ADDRESS : 66 EMMA CT  
CONTRACTOR : RBC HOMES INC  
OWNER : ABJ INVESTMENTS LLC  
PARCEL : 12-0555- - -0216- -35-  
APPL NUMBER: 09-50022914 CP NEW RESIDENTIAL (SFD)  
DIRECTIONS : T/S: 09/24/2009 01:28 PM JBROCK ----  
KENLAN FARMS #35  
US HWY 401 S TO RIGHT ON MCNEILL HOBBS  
RD TO LEFT ON WIRE RD PASS JOSEY  
WILLIAMS ON THE LEFT AND TURN RIGHT ON  
KENLAN RD

Harnett County Inspection Department  
Jimmy Hall (910)984-4768  
Permit #09-50022914  
Date: 1/06/10

RBC / Lot 35 Kenlan Farms / Harnett Co.

Job J94455	Truss J1	Truss Type MONO TRUSS	Qty 7	Ply 1	RBC / Lot 35 Kenton Farms / Harnett Co. Job Reference (optional)	E5509117
---------------	-------------	--------------------------	----------	----------	---	----------

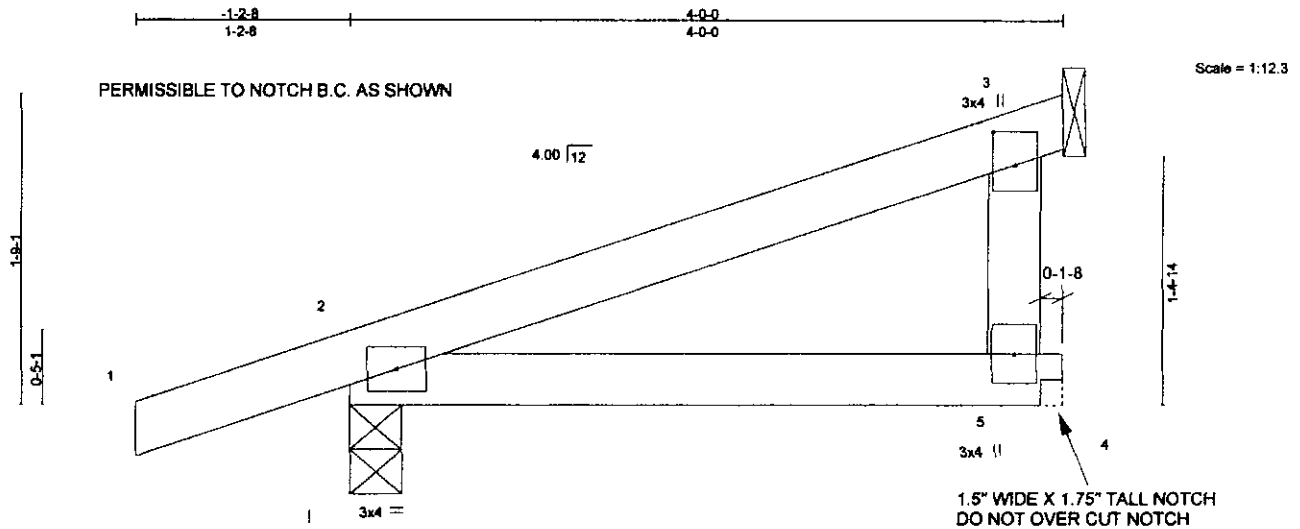
- 1) Replace damaged stud to right of garage door.
- 2) Fire caulk refrigerant lines @ top plate in back wall of garage.
- 3) Missing roof boots for plumbing.
- 4) Support all pex water lines every 32" per code.
- 5) Need 100psi on water lines test froze.
- 6) Fire caulk @top plate on vent pipe over washer box.
- 7) Top plate joint @ refrigerator needs stud under it.
- 8) Fire caulk ¾" pipe @ top plate to right of fire box.
- 9) Nail osb to right of window that is right of fire place.
- 10) Half Bath missing duct for exhaust fan.
- 11) Need 2 studs under each end of header for stairs.
- 12) Roof truss for front porch does not match truss drawings & need truss repair letter for notched truss on front porch.

CUT AND REMOVE SECTION INDICATED BY DASHED LINES. LUMBER TO BE CUT CLEANLY AND ACCURATELY, NO PLATES ARE TO BE DISTURBED.
